FILE NUMBER: Z245-167(MB) / Z-25-000017

REQUEST: An application for an amendment to and expansion of Subdistrict 1G on property zoned Subdistricts 1 and 1G within Planned Development District 621.

SUMMARY: The purpose of the request is to allow modified development standards primarily related to floor area ratio, height, parking, and landscaping.

STAFF RECOMMENDATION: Approval, subject to a conceptual plan and staff's recommended conditions.

SHEET NAME
EXHIBIT 621K
DEVELOPMENT PLAN - SUBDISTRICT 1G

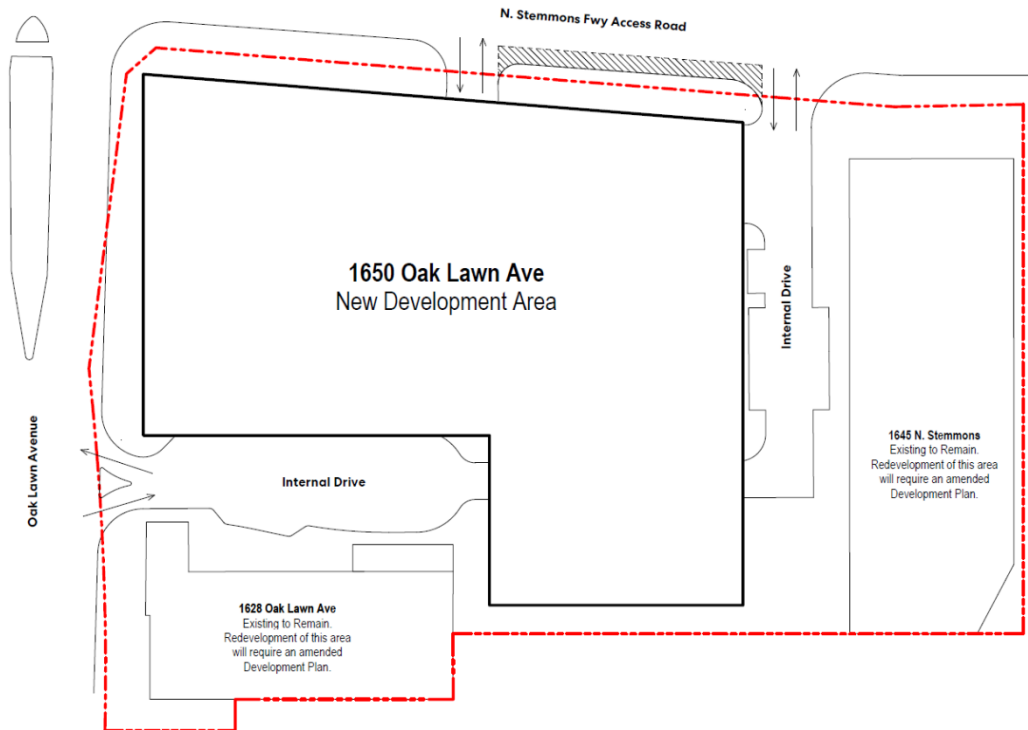
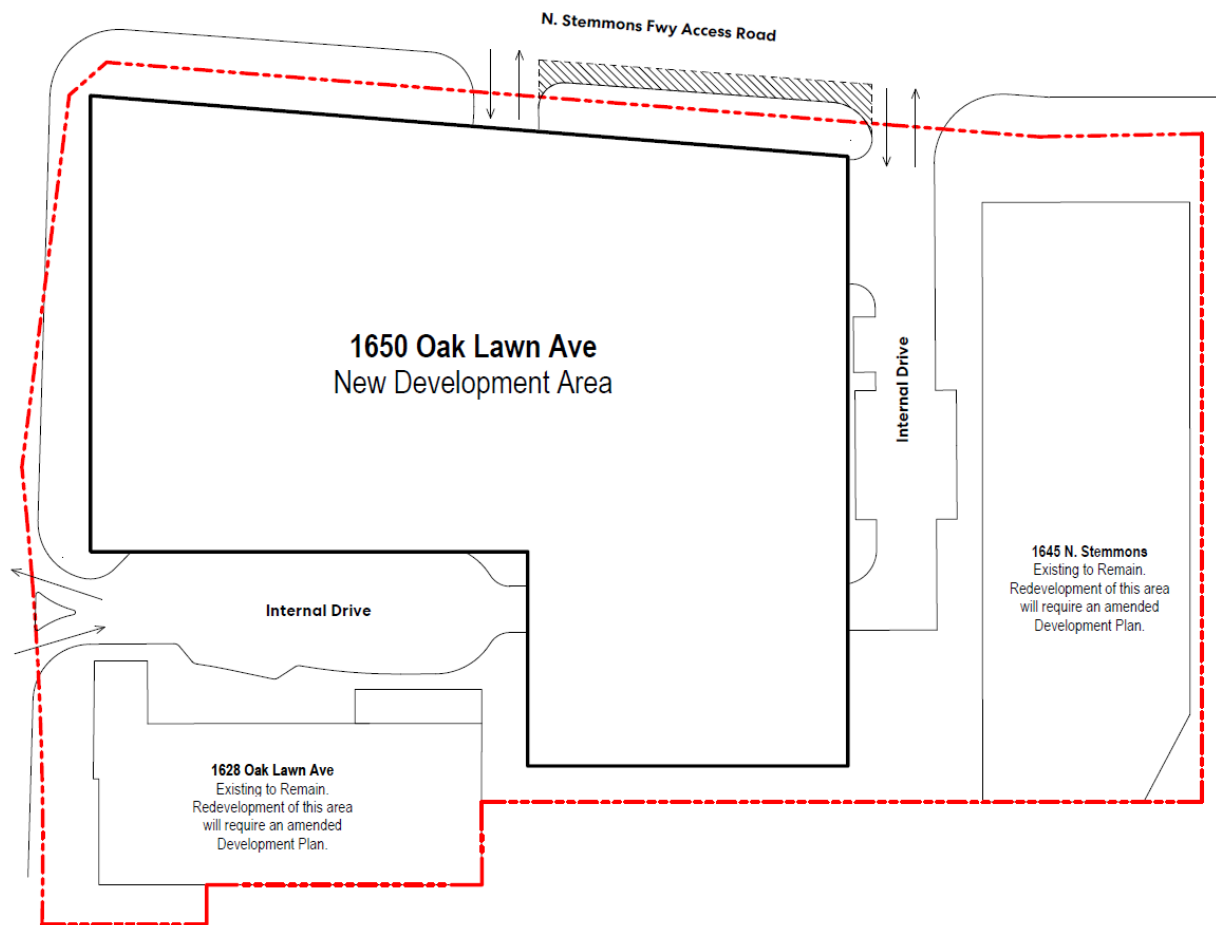
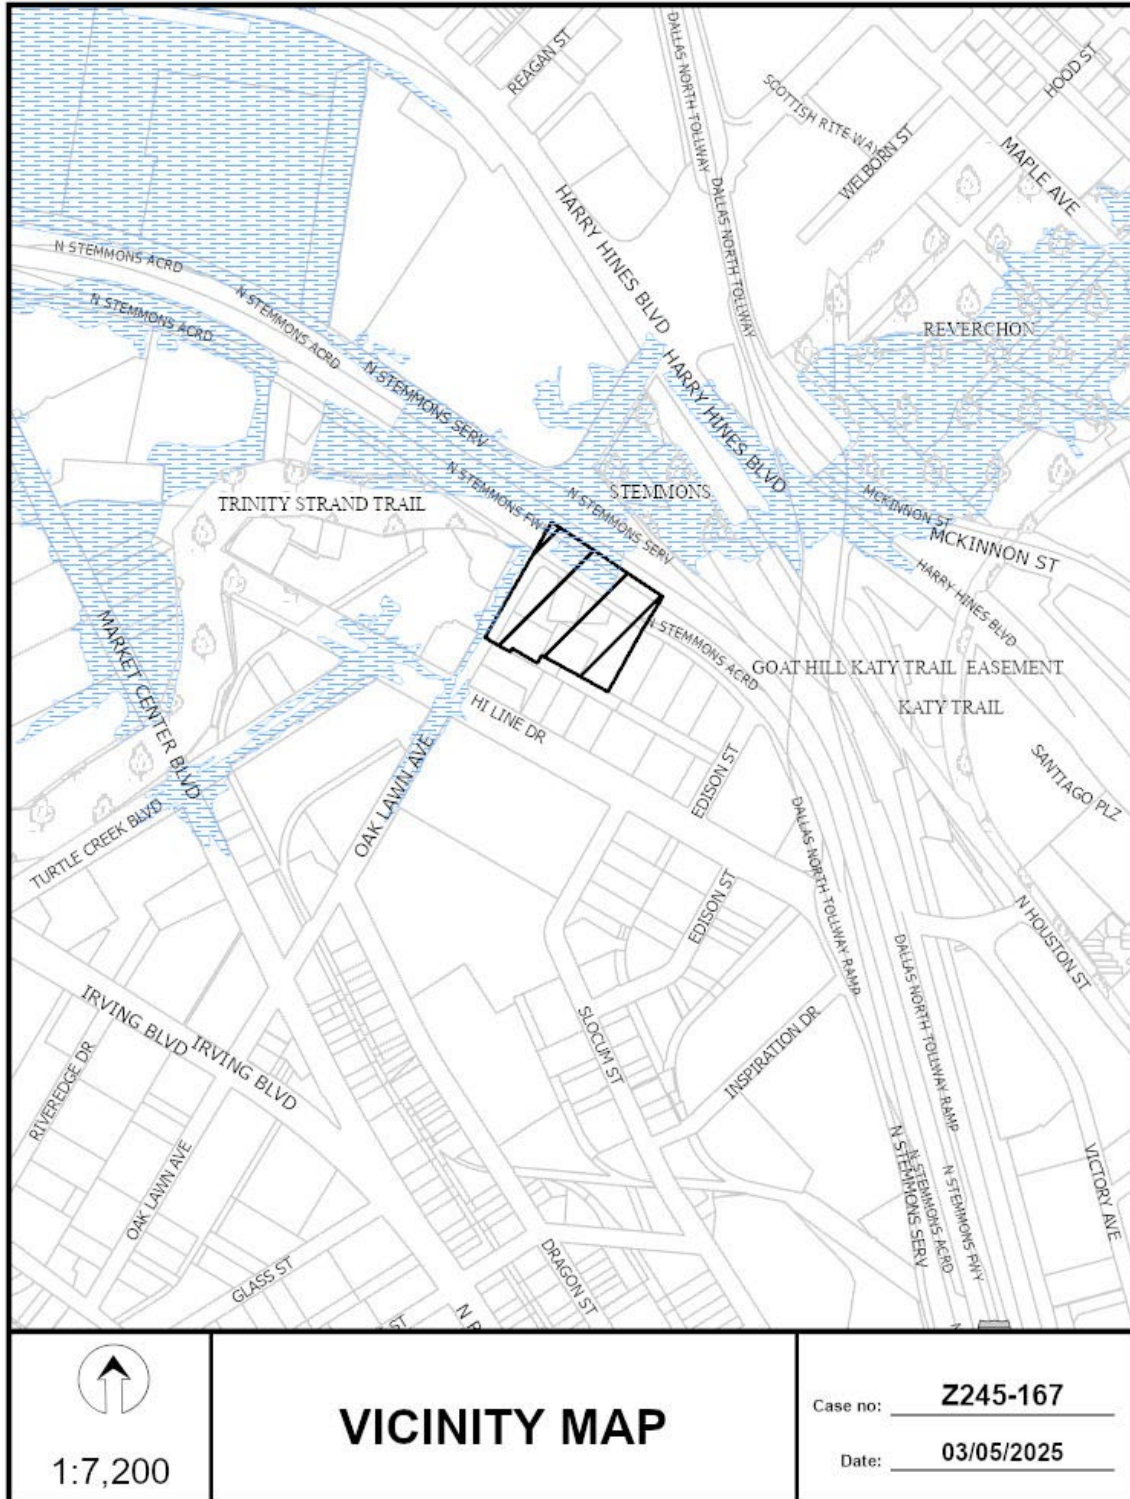
- Clarification of provided exhibits; the applicant's proposed development plan is not detailed enough to be considered a development plan, and should instead be labeled and treated as a conceptual plan. Applicant will re-plot the site in accordance with any adopted changes to the subdistrict.

STAFF RECOMMENDS REMOVAL

- (a) Except as provided below, there is no conceptual plan for this special purpose subdistrict.
- (b) Development and use of the Property in Subdistrict 1G must comply with the conceptual plan (Exhibit 621K).
